Submission to the AER on its Preliminary Determination Asset Renewal

This document sets out Ergon Energy's response to the Australian Energy Regulator (AER) on Asset Renewal Expenditure.

Figure 1 Ergon Energy Total Assets Age Profile

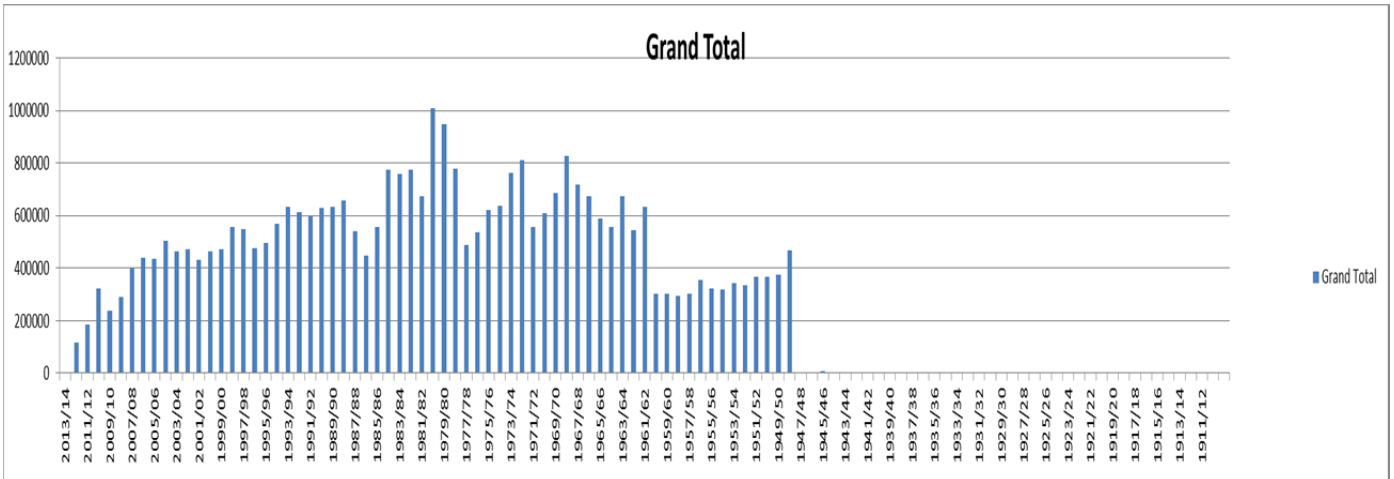
As part of the revised proposal could Ergon provide an update with age profile data for the year 2014–15 for these same categories (or to match any updated re-categorisations if there will be any as part of the revised proposal)."

Figure 1 shows that it is apparent that there is no even distribution of asset age. It is also apparent that it is difficult to ascribe a simple mathematical function to describe the distribution.

To return to actual information, Figure 1 provides actual total age profiles. If this represented a single asset class, it would be more likely to be the right hand end of the curve that would be targeted for replacement, rather than the average. This is why Ergon Energy does not use average age of asset classes to decide upon strategies for refurbishment

Figure 5 Comparison of the repex models and Ergon Energy's expenditure forecasts by asset group (in 2013-14 real dollars)

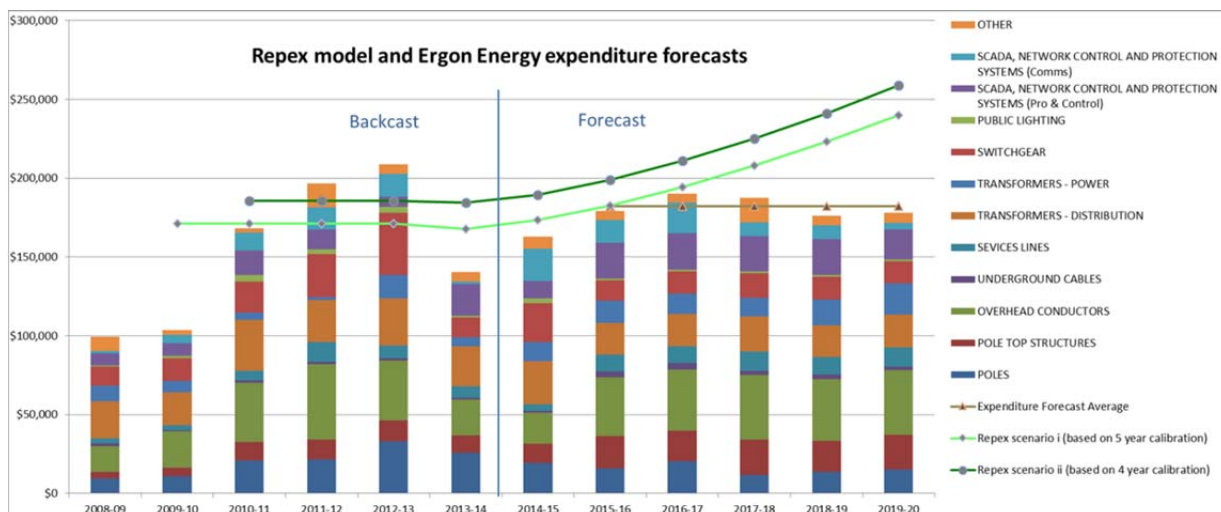
It is not within our scope to consider the validity of the repex model output that Ergon presented. However, if the outputs are valid, then they appear to show that the proposed repex program is within the bounds indicated by the repex model⁶²

Ergon Energy developed a suite of repex models as part of its proposal based upon the reset RIN data. This calibrated model was documented in proposal document, *07.01.44 Repex Model Mark III Report 2013-2014*. Figure 5 of that document details the overall outcome of the modelling, and is reproduced in Figure 5 below.

While Ergon Energy questions the validity of the RIN data asset categorisation employed by the AER, (discussed in section 4.1 and following sections), Ergon Energy's proposal document, *07.01.44 Repex Model Mark III Report 2013-2014*, section 7.2 to Section 7.4, demonstrates that Ergon Energy reviewed the overall repex model outputs (refer *07.01.44 Repex Model Mark III Report 2013-2014*), discussed the model output trend and made comparisons in relation to the overall repex forecast expenditure proposed. This top-down review and discussion revealed that Ergon Energy's replacement expenditure proposals were generally lower than the repex model outputs, created based upon the datasets as nominated by the AER. Ergon Energy specifically documented how this was achieved in its proposal document *07.00.01 Forecast Expenditure Summary Asset Renewal 2015 – 2020* Section 7.1

Figure 6 CBRM Substation Power Transformers - HI Comparison - No Intervention vs proposed Intervention

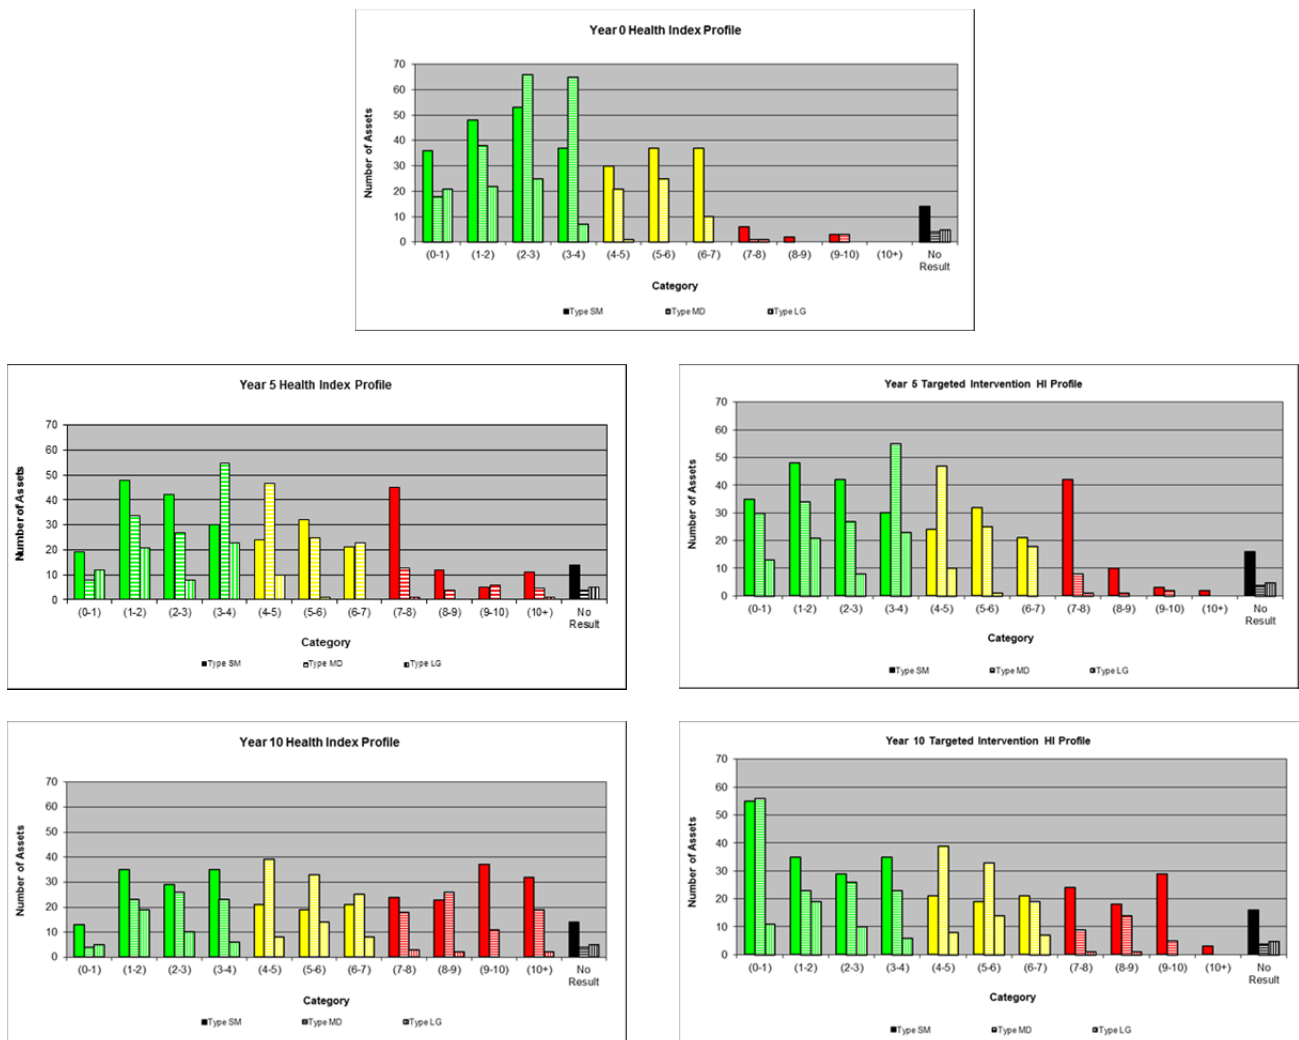
We expected to see a greater level of analysis of condition of this asset category, including presentation of the changing HI over time for sub-categories of this asset class. In the absence of this analysis being provided, our review of Annex B suggests that several power transformers with a low HI (less than 4) at year 10 appear to have been included in the replacement plan.

EMCa were critical of Ergon Energy's CBRM based engineering reports as they did not provide indications of health indices changing over time. Ergon Energy's approach, described in various submission documents, is that while health indices represent asset condition, such condition is only part of the picture. Each asset exists in a unique part of the power network, and the position in the network and its related impact upon nearby assets and provision of service are also important

For the avoidance of doubt, Figure 6 provides the impact of changing health indices for power transformers, which are routinely generated as part of the CBRM model. It demonstrates that the current health of the population (the Year 0 graph) will slowly degrade over the next 10 years, however with no intervention (left hand side of figure), the degradation will markedly accelerate compared to the proposed replacement process (right hand side of the figure)

Comparison of the two year 10 charts reveals the intended impact of the proposed repex forecasts. Red represents those assets with poor health index (very poor condition), green with excellent/good

health index (very good condition), and yellow represents fair condition. The targeted intervention chart (right hand side) details expected asset condition following Ergon energy's proposed replex expenditure. The other chart (left hand side) details expected asset condition with no intervention (i.e. only replace on failure). Ergon Energy's strategy to replace highest risk assets also accomplishes replacement of most of the assets with worst condition.
